SUBJECT: To disable ink detection circuit

SUBJECT: Master Feed Jams

SUBJECT: Master Eject Jams

SUBJECT: Ink Pump Improvement

SUBJECT: Paper feed pressure

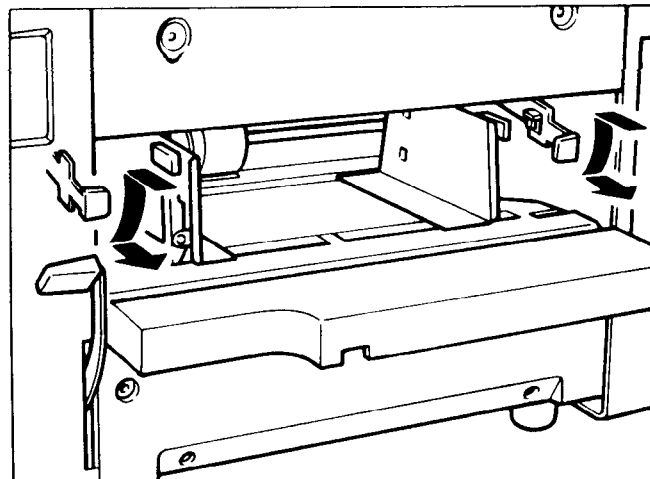
When 500 sheets of standard paper (80g/m<sup>2</sup>) is set on the paper table, paper misfeeds would occur. This is because not enough feed roller pressure is applied due to friction between the paper stack (leading edge side) and the lower paper feed guide which guides the leading edge of the paper stack.

In this case, advise your customer to change the position of the pressure adjustment levers, as shown below, to increase paper feed pressure.

We confirmed that even if the pressure adjustment levers are in the lower position, normal paper (70g/m to 200g/m) would be fed properly. So from August '93 production, the pressure adjustment levers have been set in the lower position (stronger pressure) in the factory.

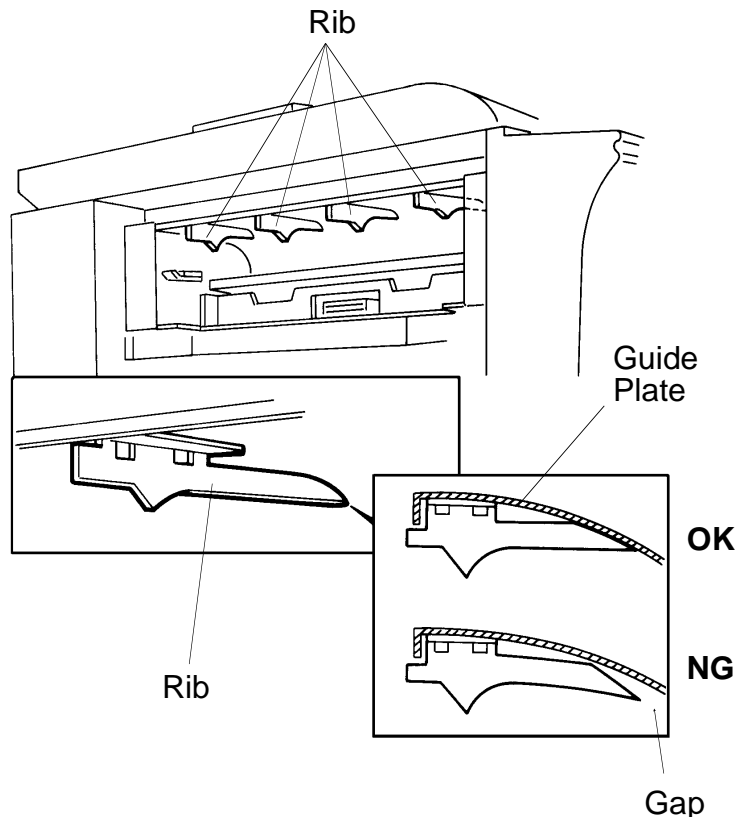
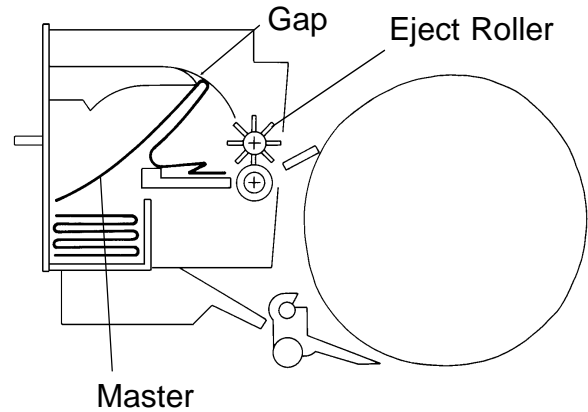
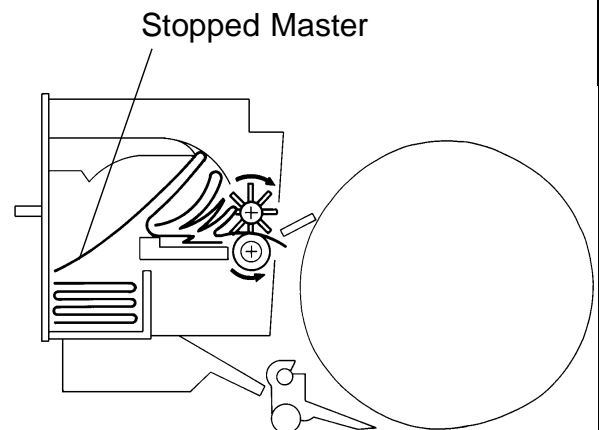
1. Frequent master eject jams at location "F".
2. The master wraps around the upper and/or lower master eject rollers.
3. "F" jam cannot be reset because the actuator (feeler) of the master eject sensor remains pushed down by the pressure plate. (The actuator comes under the pressure plate.)

There are 4 ribs to guide the ejected master in the master eject unit. There is a small gap at the leading edge of the ribs against the guide plate.

Due to a part variation, if the gap is too big, the master tends to be caught by the ribs. A jam or other problems may occur as per the following sequence:

1. While the master is being removed from the drum, the leading edge of the master goes properly into the master eject unit. At this point, however, while the pressure plate moves to compress the master in the eject box, the middle part of the master tends to rub against the ribs. If there are any gaps, the master is caught by the ribs. (The master therefore remains caught by the ribs.)

2. If no jam is detected by the machine after the above situation has occurred, the machine can carry out the next master eject. However, the next ejected master interferes with the master caught by the ribs and is stopped just behind the eject rollers.

As result, "F" jam will be indicated. Otherwise, if there is no space for the master to proceed (due to the previous master jam), the master is again caught by and wraps around the eject rollers. If the master is stopped just on the master eject sensor, the sensor feeler remains pushed down while the pressure plate is traveling. After the pressure plate returns to its home position, the sensor feeler comes under the plate. ("F" jam is then indicated and cannot be reset.)

### Solution 1 (For the mass production units)

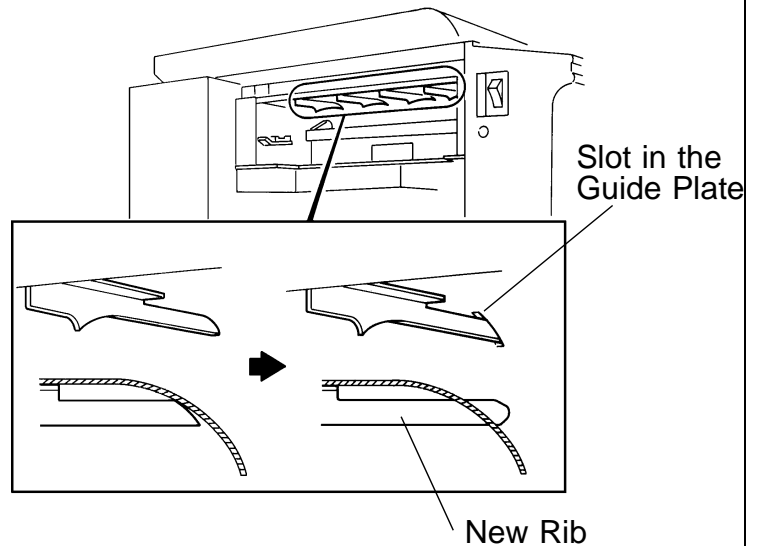
The ribs fixed (welded) to the guide plate have been changed as shown to prevent any gap at the leading edge.

The part number of the guide plate (Guide Plate - Eject Unit) has been changed from #C2173565 to #C2173567.

The new guide plate will be applied into the production from June 1994.

### Solution 2 (For the field units)

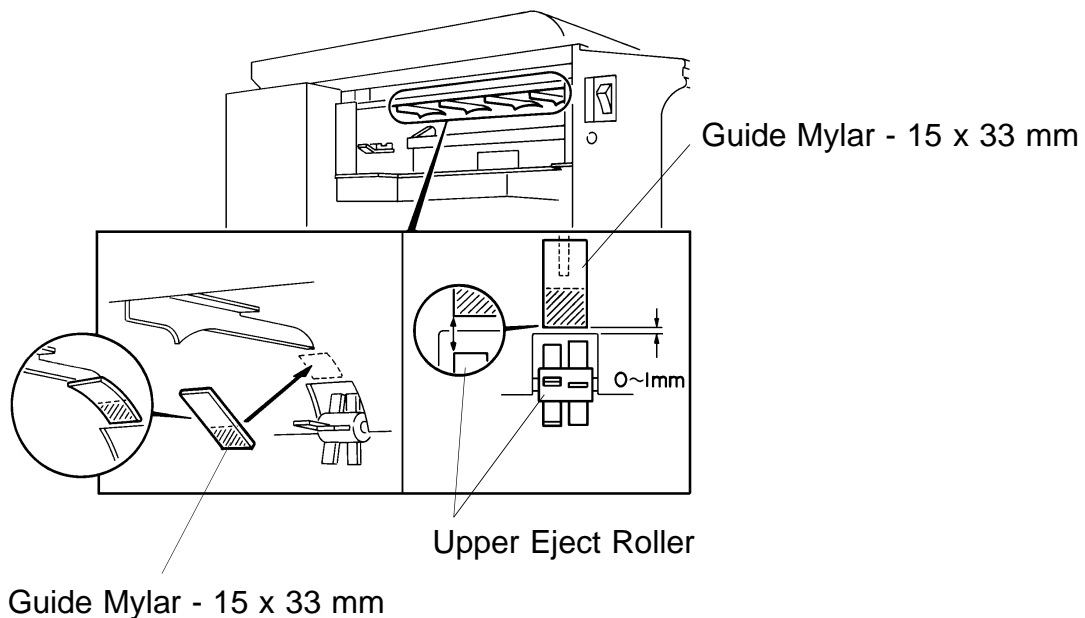
As a solution for the field units, a mylar strip (**Guide Mylar - 15 x 33 mm: P/N C2179500**) has been registered as a service part. Install the mylar strips on the leading edge of the 4 ribs to cover the gap as shown.

**NOTE:** 4 mylars are required for one unit.

**Cross-section of the Bottom Part of the Ink Pump**

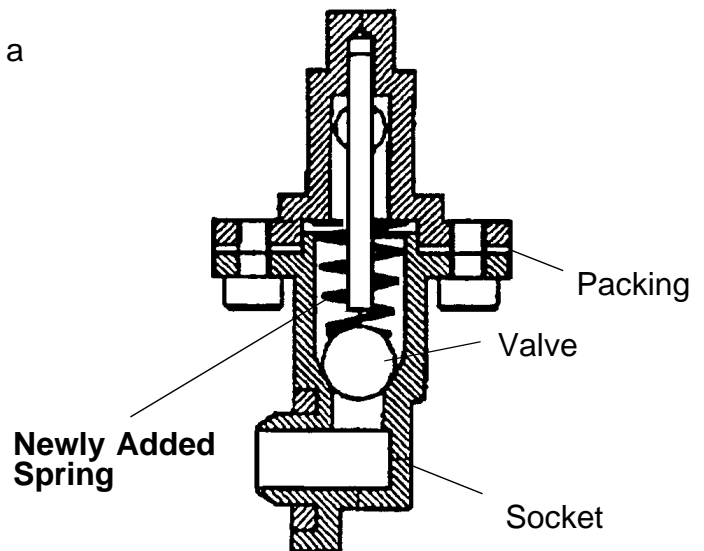
To ensure that all ink in the cartridge is supplied, a spring has been added inside the ink pump as shown to the right. The spring ensures that the small ball, which is used as a valve, is pushed back properly.

This modification has been applied from the September 1995 production runs of all Priport series models. The part numbers of the ink pump assemblies remain the same. (Note that the N850 and RN925 have been using the new type from the first mass production.)

### SOLUTION IN THE FIELD

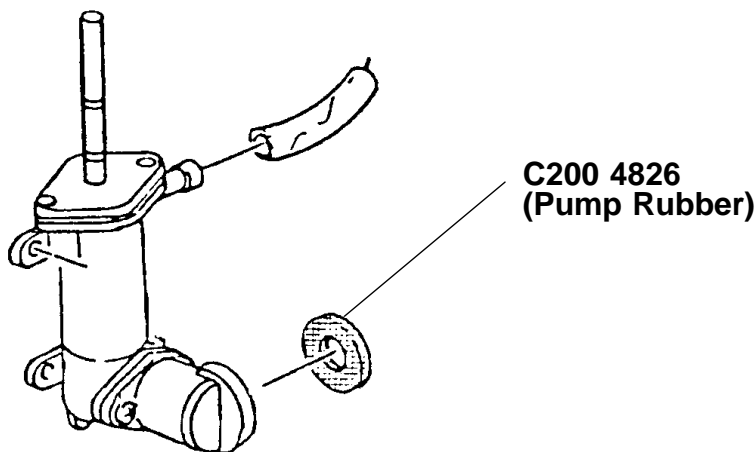
For the field machines, you can install the spring after removing the socket (with two screws). (It takes longer to replace the whole pump assembly.)

**CAUTION:** When you remove the socket, ink will leak. Be sure to place absorbant material to prevent the floor from becoming dirty with ink.

**NOTE:** 1. There is a packing between the socket and housing (see the illustration on the previous page). If it is damaged, you may have to replace the packing at the same time. (Normally, this is not required.) The part number is:

SUBJECT: Thermal Head Removal Procedure for N810-II

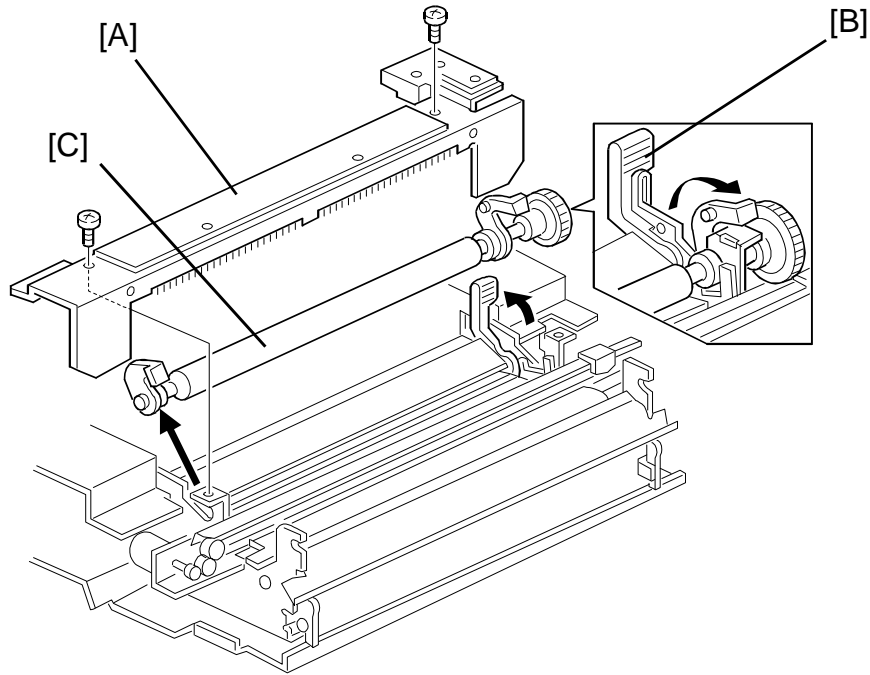
A cutout has been made in the rear side (non-operation side) frame of the plotter unit. (The part number: C2174102, remains the same, but all service parts are the new type only.) This enables the removal of the thermal head (with the bracket) without having to forcibly spread out the side frames. Refer to the new thermal head removal procedure.

This modification will be applied from the April 1996 production run.

**THERMAL HEAD REMOVAL PROCEDURE (New Procedure)**

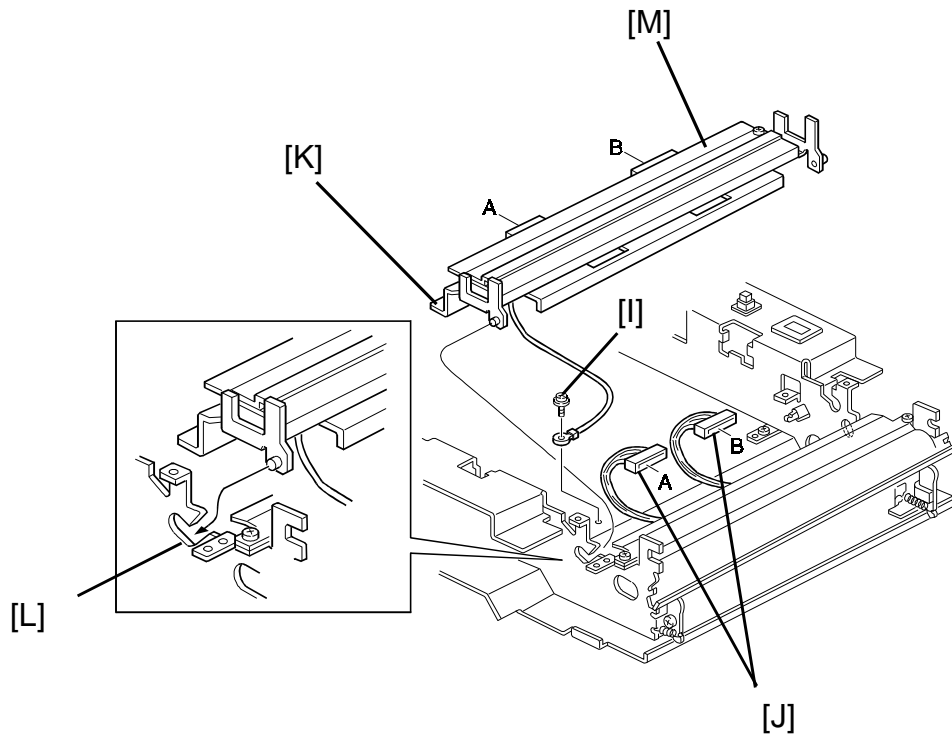
10. Unhook the pins on non-operation sides of the thermal head bracket [K] through the cutout [L] and remove the bracket (with the thermal head).

**NOTE:** The cutout [L] has been newly added.

### For N810 and N810-II Models

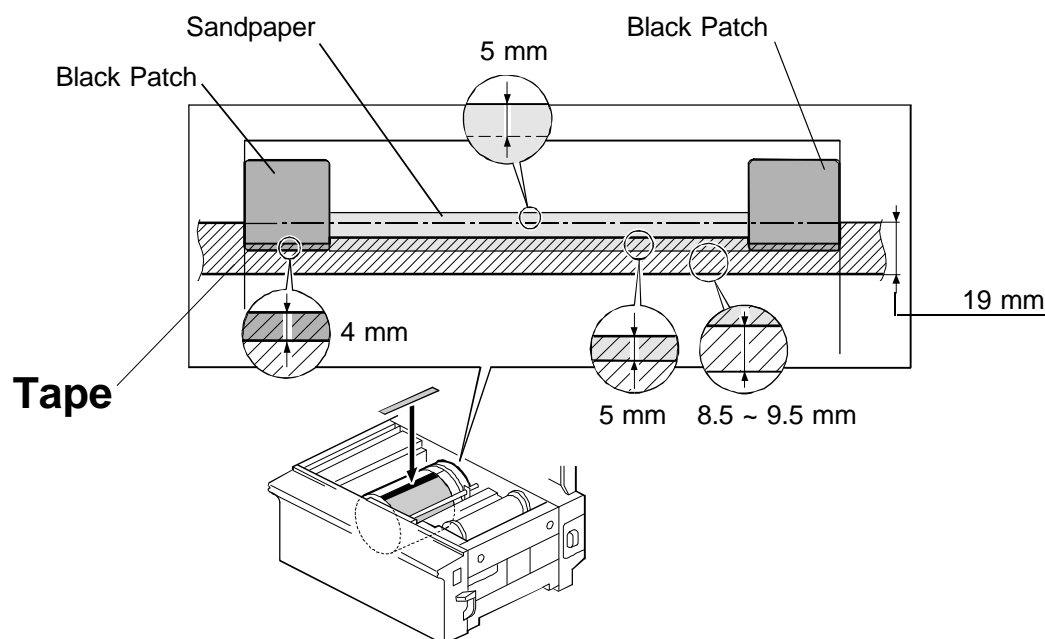
- Cut the tape where it covers the sandpaper as shown. (The indicated area must be left as shown to hold the tape on the screen firmly.) Be careful not to damage the cloth screen surface.
- **Also, cut the tape where it covers the black patches (for the drum master detection sensor) as shown. If they are covered, drum master detection does not work properly.**
- Cut both edges of the tape at the edge of the metal screen. Do not let the tape ride over the drum flanges.
- Even if the sandpaper is not used on the cloth screen (the old type cloth screen), install tape at the same position by measuring the distance from the edge of the black patch to the lower edge of the tape (between 8.5 and 9.5 mm).

**For NA33 model**

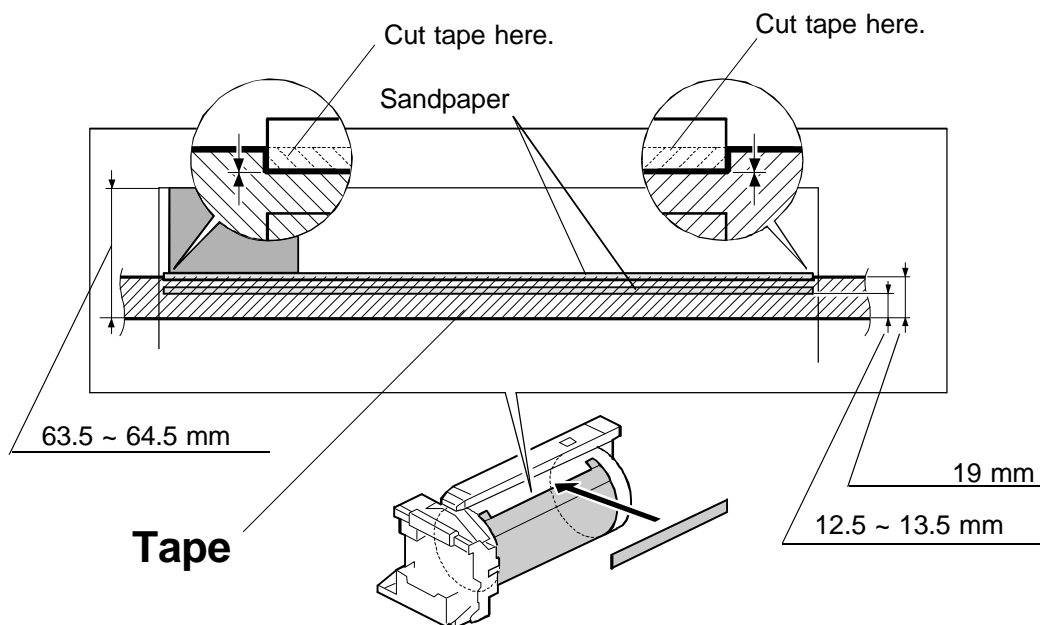
- Cut the tape where it covers the upper strip of sandpaper as shown. Be careful not to damage the cloth screen surface.
- Cut both edges of the tape at the edge of the metal screen. Do not let the tape ride over the drum flanges.

### For NA3 and NA2 Models

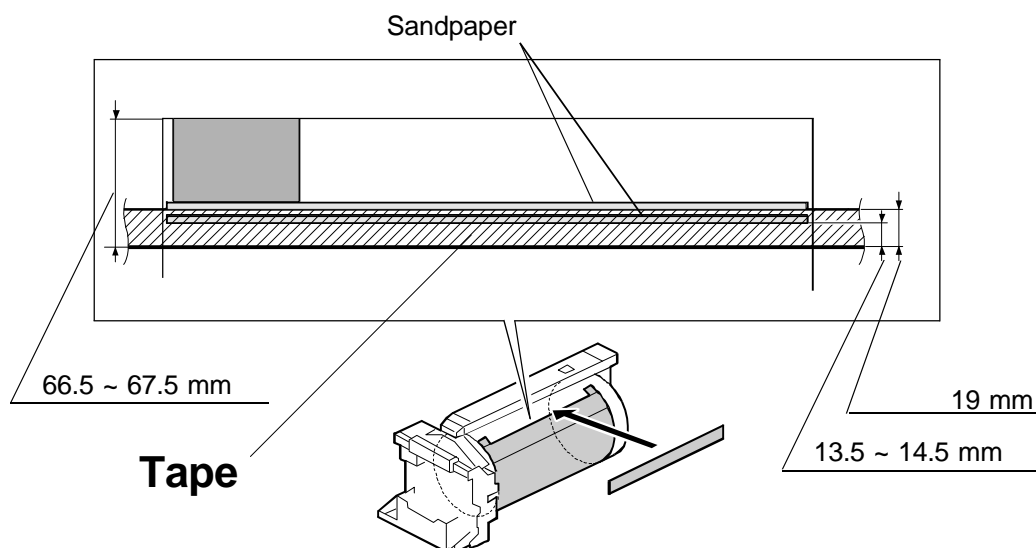
- The position of the tape is slightly different from that for the NA33 model since the specification of the leading edge blank margin is different. (The position of the sandpaper is also different.) The upper edge of the tape should meet between the two strips of sandpaper. You do not have to cut the tape (unlike in the case of the NA33 model).

- Cut both edges of the tape at the edge of the metal screen. Do not let the tape ride over the drum flanges.
- Even if the sandpaper is not used on the cloth screen (the old type cloth screen), install the tape at the same position by measuring the distance from the edge of the cloth screen to the lower edge of the tape (between 66.5 and 67.5 mm).

- Since the specification of the leading edge blank margin for the NA2 model is 10 mm (8 mm for the NA3 model), it is permissible to install the tape 2 mm lower than the position indicated above (NA2 only).

### For RN925, NB2, N850, N860, N865, N915, N935, and N955 Models

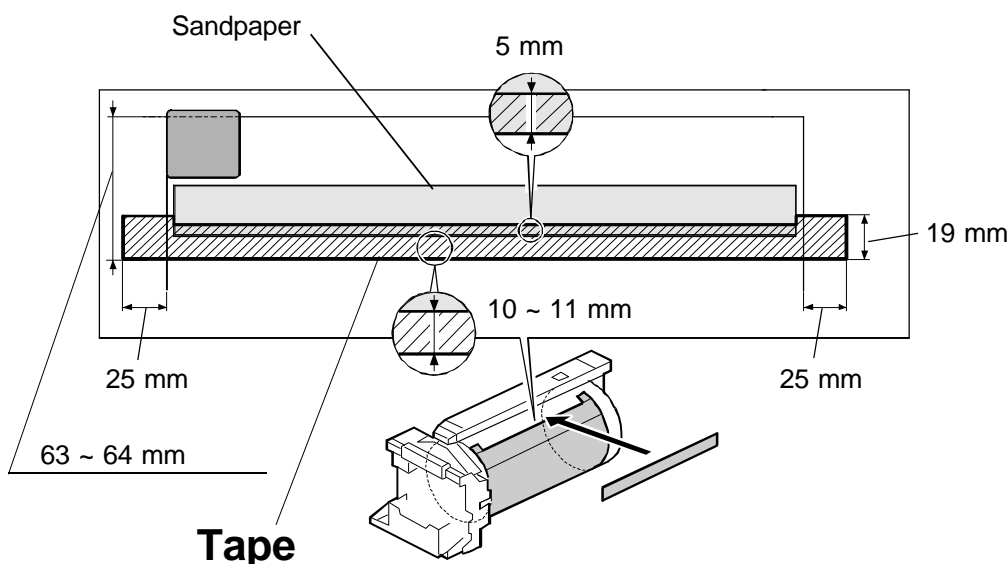
- Cut the tape where it covers the sandpaper as shown. (The indicated area must be left as shown to hold the tape on the screen firmly.) Be careful not to damage the cloth screen surface.
- Cut both edges of the tape as indicated.
- Even if the sandpaper is not used on the cloth screen (the old type cloth screen), install tape at the same position by measuring the distance from the edge of the cloth screen to the lower edge of the tape (between 63 and 64 mm).
- Since the specification of the leading edge blank margin for the N915/935/955 model is 10 mm (5 mm for the other models), it is permissible to install the tape 5 mm lower than the position indicated above.
